ADDENDUM NO. 2

WATER SERVICE REPLACEMENT 17/18 – CITY PROJECT NO. C67501713 WILSON – WEBSTER WATER MAIN REPLACEMENT – CITY PROJECT NO. C67401916

July 9, 2018

DETAIL 5 VAR 1.5" SPLIT SERVICE

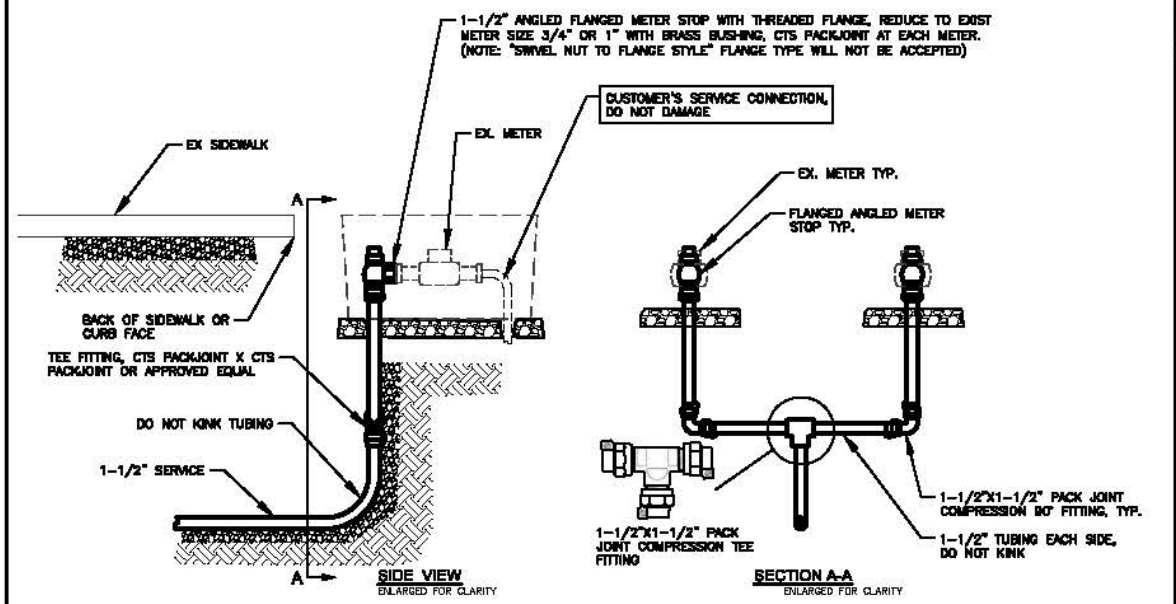
Q: On sheet C1 the note says to install split service per detail on Sheet D-1, & another note on sheet C-9 saying to install 2” service & manifold per detail on sheet D-1. Details are not found on D1. Could these details be provided?

A: Yes, Sheet D1 page 23 of 23 is amended to include a 1.5” split service detail. See City standard 865 & 885 for 2” manifold service. Amended page D1, Sheet 23 attached.
